**HARRIS TEETER AT LADY'S ISLAND**  
**CITY OF BEAUFORT – DRB CONCEPTUAL RESUBMITTAL**  
**PROJECT NARRATIVE**  
**Submittal Date: April 5, 2016**  
**Meeting Date: April 14, 2016**

**CITY OF BEAUFORT  
DESIGN REVIEW BOARD  
Staff Report  
Special Meeting of April 14, 2016**

**Case Number:** 16-01 DRB.4  
**Project:** Harris Teeter on Lady’s Island  
**Property Address:** 163 Sea Island Parkway – NE Corner of Hwy 21 & Hwy 802  
**Parcel #:** R123 015 000 0587 0000; R200 015 000 0592 0000  
**Zoning:** General Commercial  
**Design District:** Lady’s Island Village Center Design District  
**Type of Review:** **Final Site Plan Review – New Construction**

DRAWING TITLE	
LANDSCAPE PLAN 'A'	
DRB SUBMITTAL	
DATE:	04-05-16
PROJECT NO.:	15104.01
DRAWN BY:	MY/JB
CHECKED BY:	DK
REVISIONS:	
DRAWING NUMBER	
L2

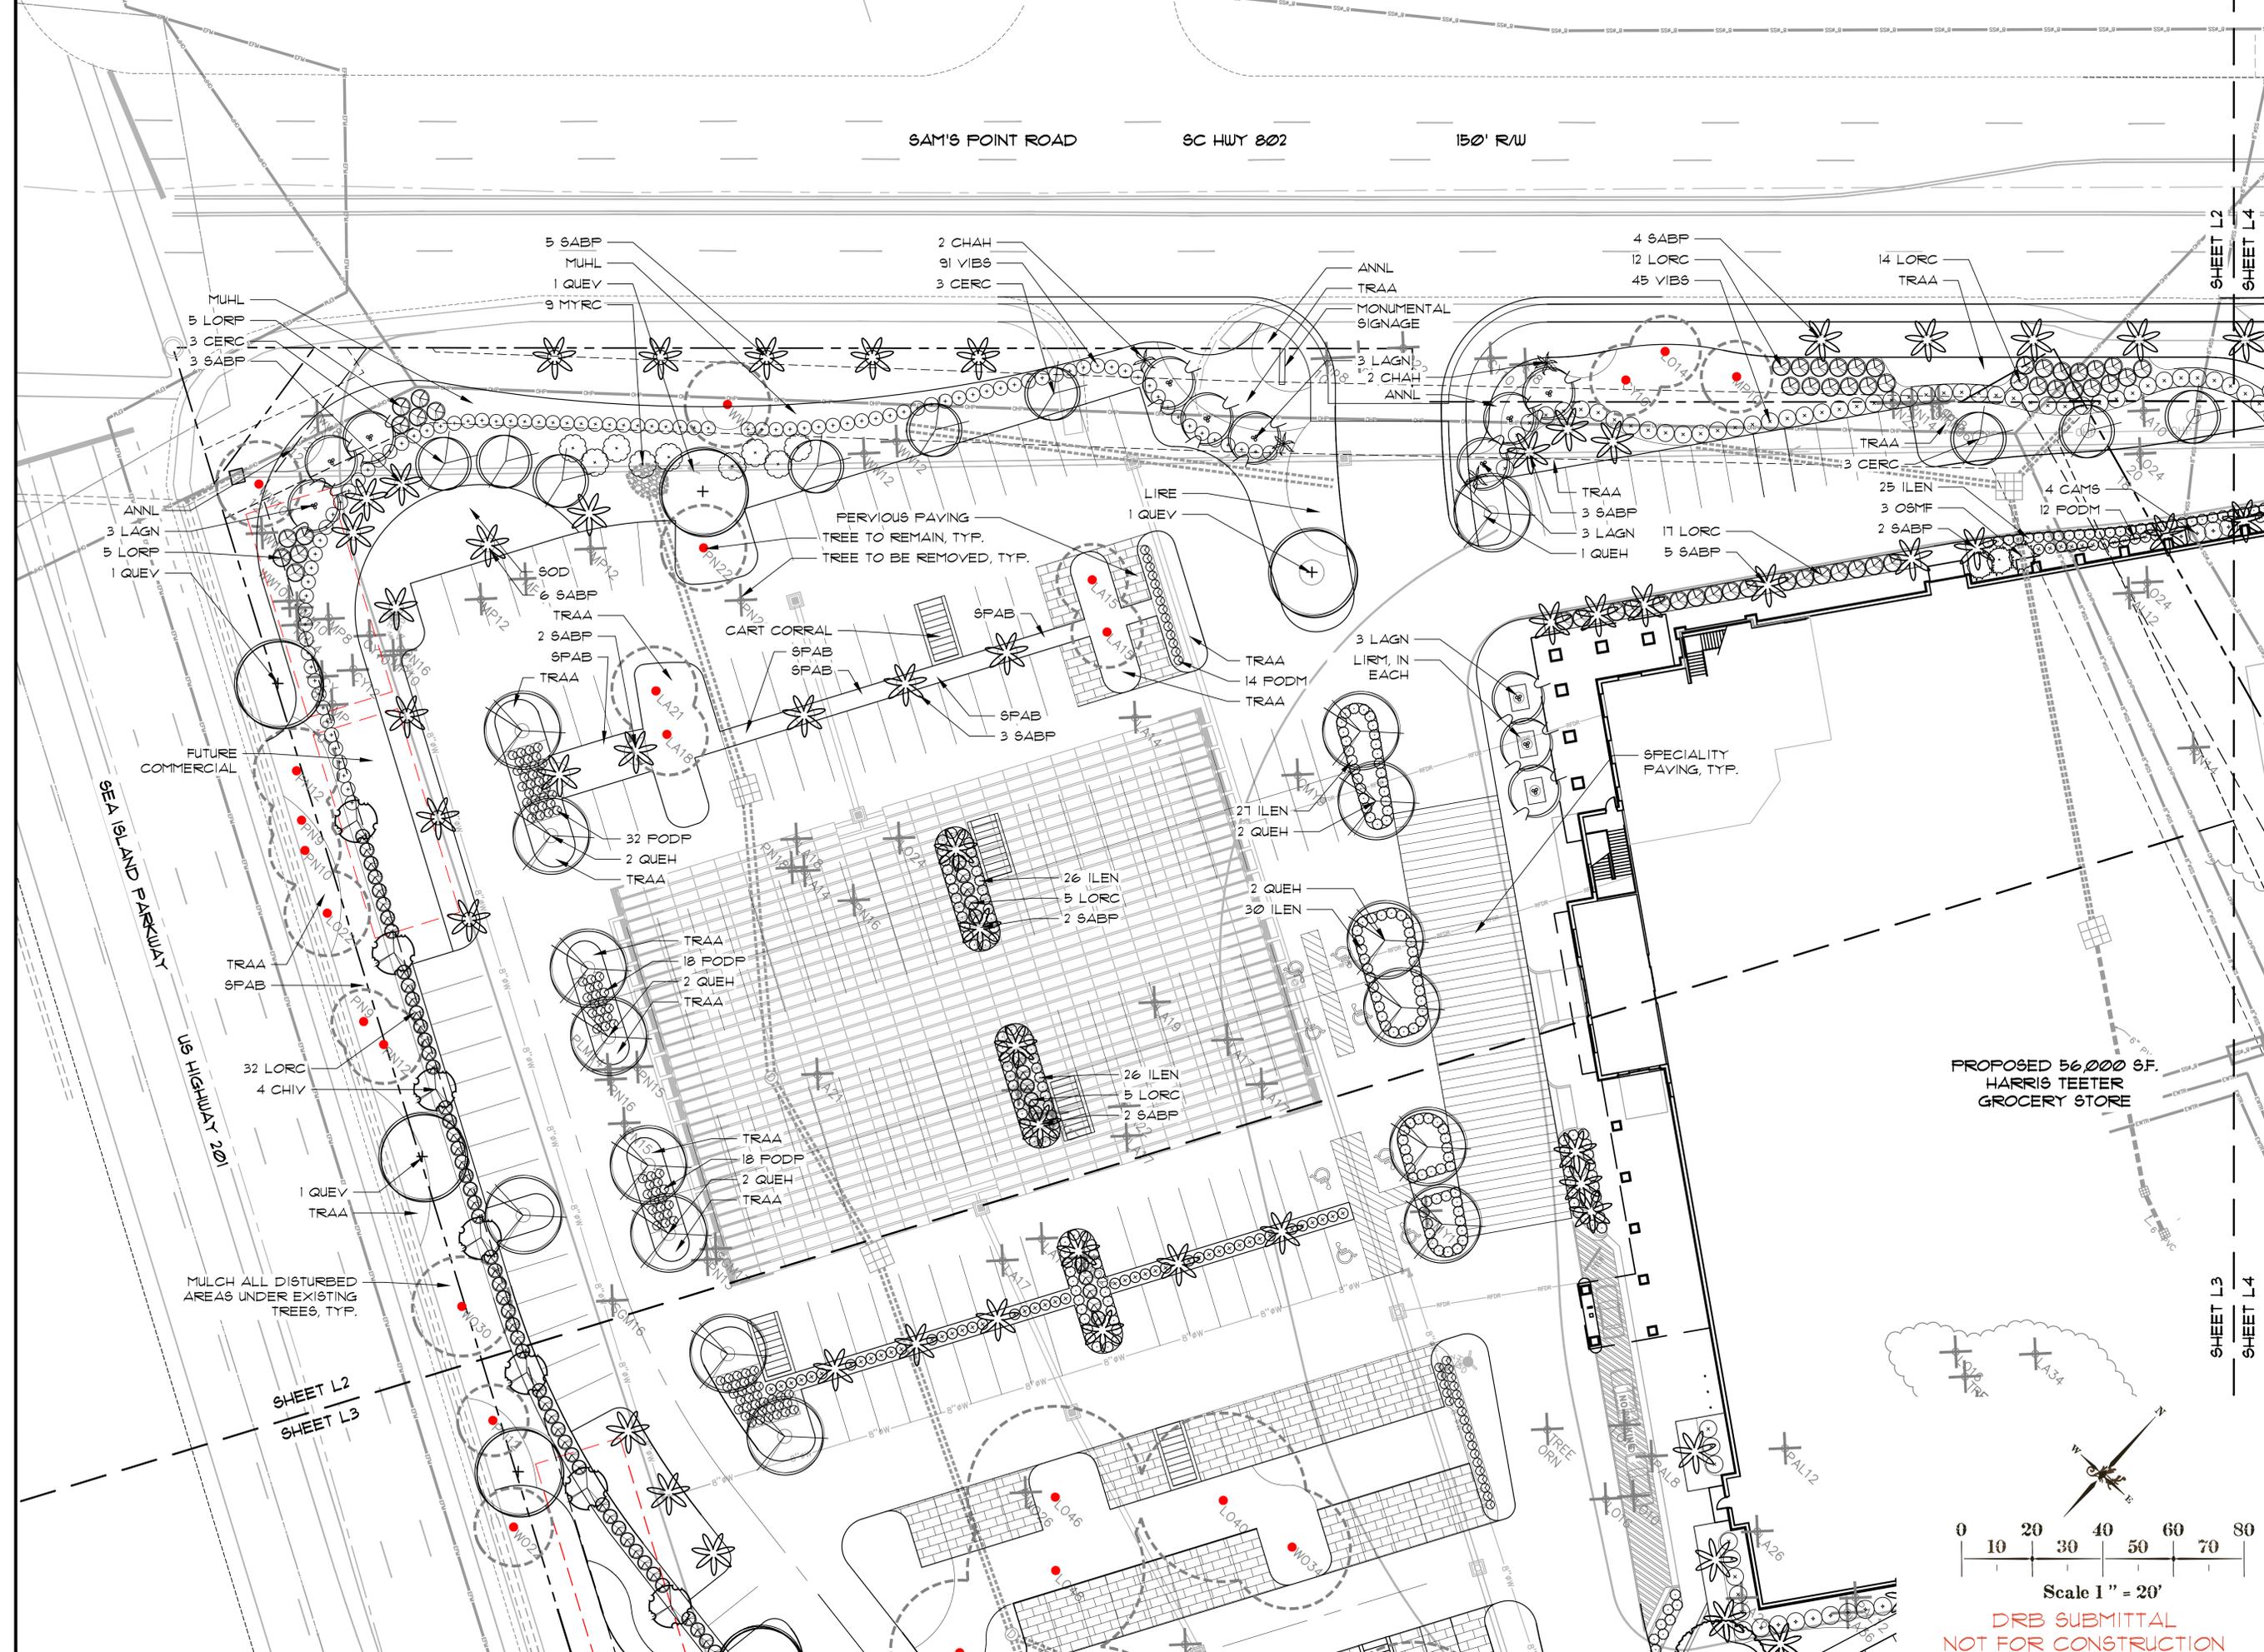
- Tree planting required at end of each parking aisle (see easternmost parking bays and area to west of 2 parking spaces at convenience store; 5 trees total)

- Require more understory vegetation and/or wall as screening for rear

delivery area. Recommend additions of evergreens, full to ground, such as Ilex 'Mary Nell' and evergreen understory trees such as Loquat and Little Gem Magnolia.

- Palms shown as street tree planting on Hwy 802. Recommend reducing on center spacing from 30' o.c. to 20' o.c. Possible addition of 9 palms.
  - Request all sodded areas be indicated.
